CONTRACT ADDENDUM NO. 3

April 6, 2026

NOTICE TO ALL BIDDERS FOR THE: **Topeka & Shawnee County Public Library** Staff Spaces Renovations HTK Project No.: 2001.01-021

NOTES:
 REFER TO SECTIONS AND DETAILS ON ALL OTHER SHEETS FOR APPLICABLE NOTES NOT SHOWN.

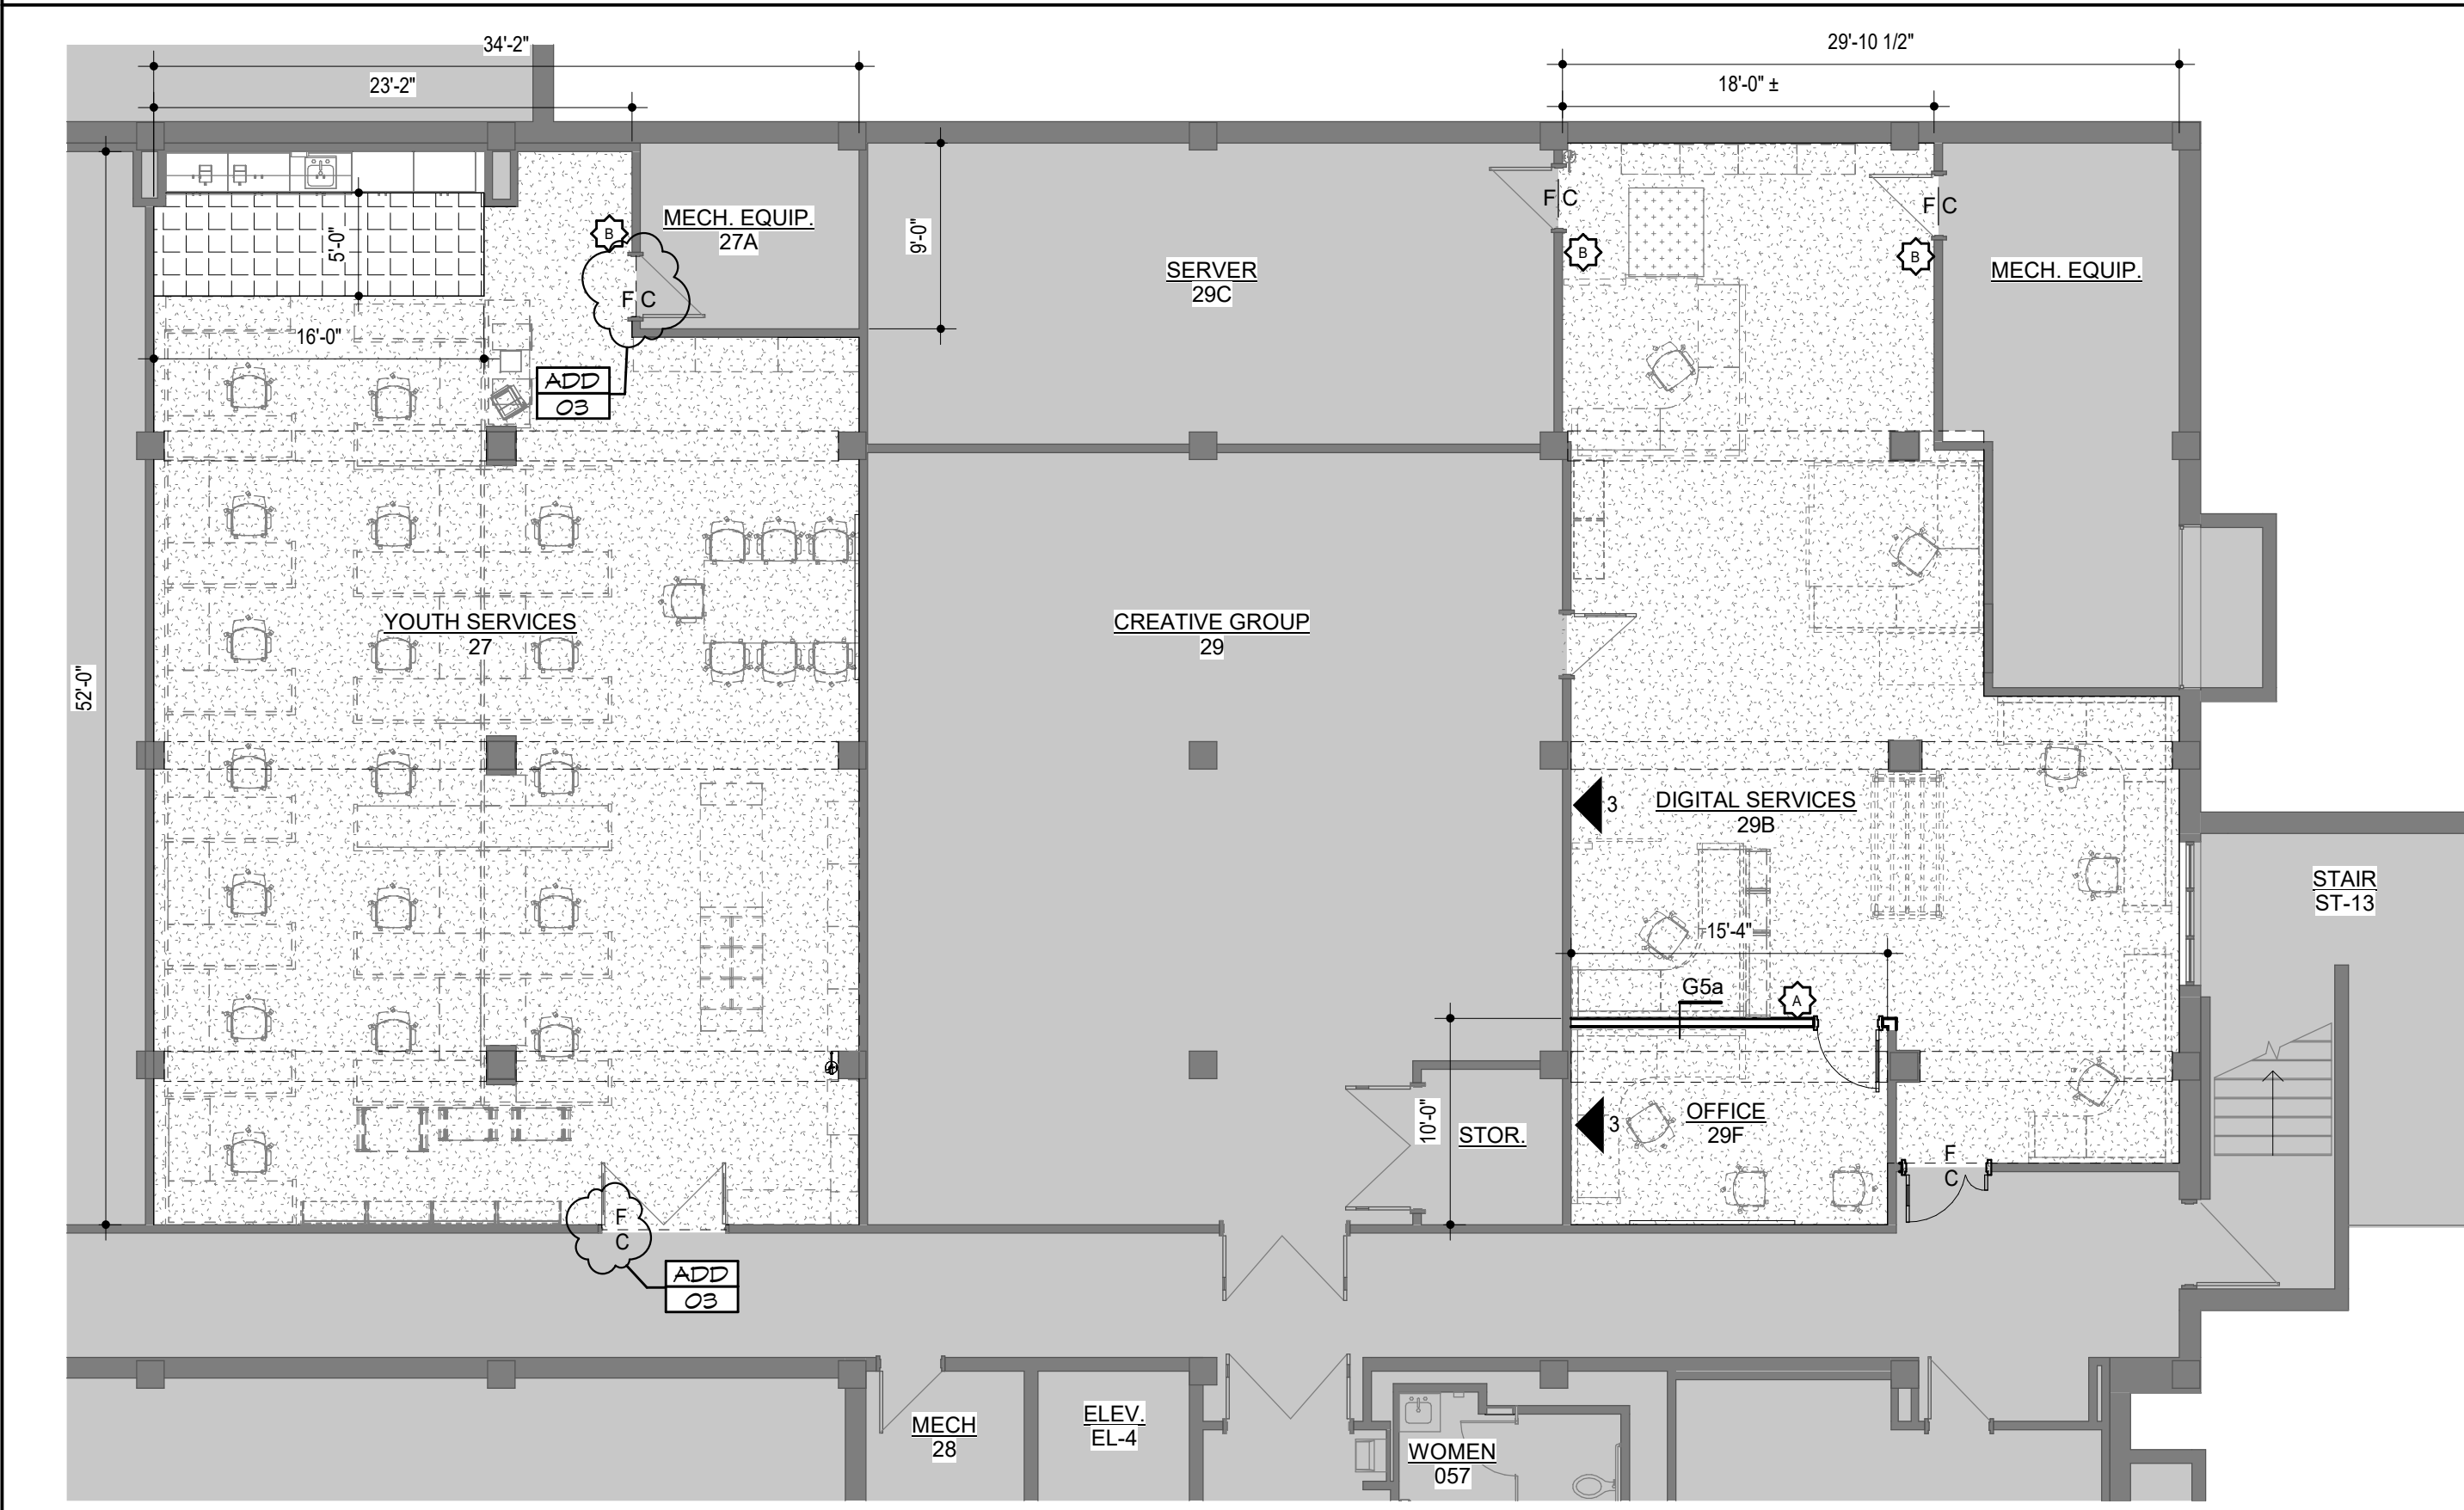
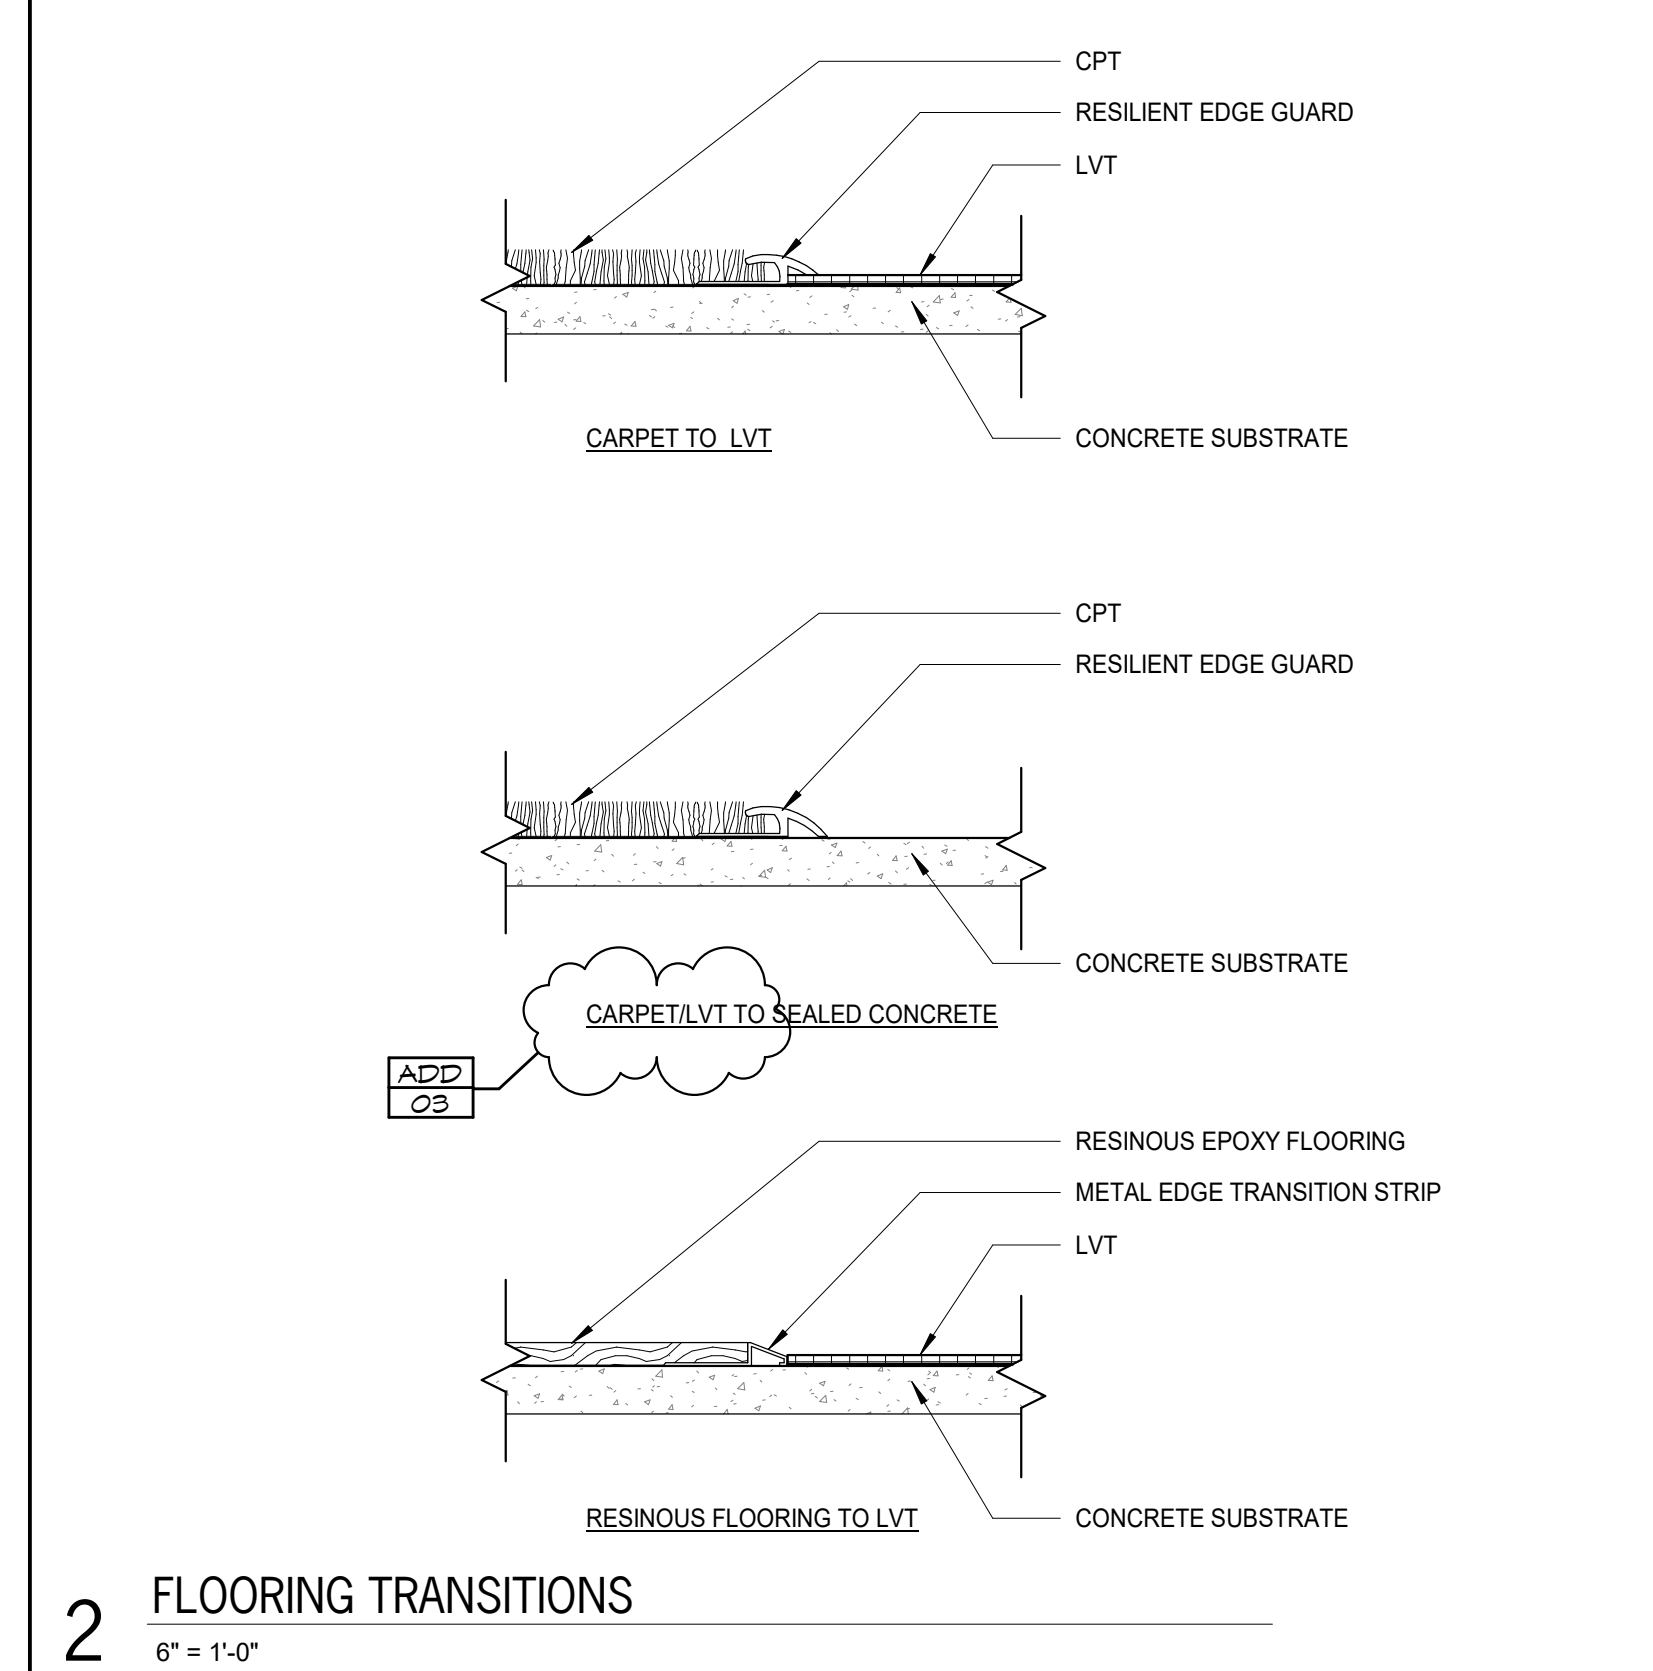
1. Provide Resilient Edge Guard between new Carpet Tile or LVT and Sealed Concrete as indicated in revised 2/A701.
2. Provide transition strips as shown on revised 1/A701.
